Item Change – Air Top 2000 Power/Switch Harness

01-20-2002

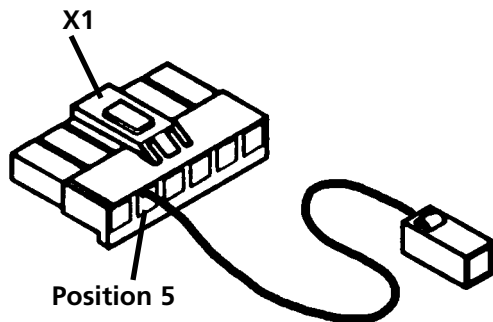
Starting the last quarter of year 2001, all Air Top 2000 Power/Switch harnesses were redesigned to omit the diagnostic link. A new Item is now available to take the place of the diagnostic link which was previously part of the harness.

For Webasto service facilities and end-users utilizing the PC diagnostic capabilities of the Air Top 2000 heater, the NEW adapter (pigtail) is required to allow communication between the heater and the diagnostic kit where the new power/switch harness is in use. The new adapter can be ordered under part number 5000007A.

The new adapter (pigtail) is inserted into position 5 of the X1 connector that plugs into the control circuit board. Once installed, the diagnostic kit can be connected in the usual manner as before, using the appropriate diagnostic adapter (P/N 92566B) included in the PC Diagnostic kit.

New Adapter (Pigtail) P/N 5000007A

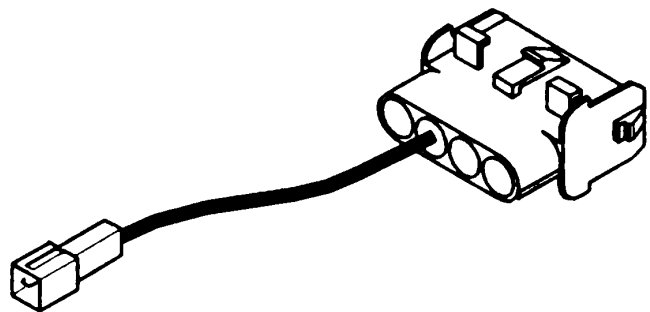
The above items illustrated can be ordered separately or together as a kit under part number 5000009A.
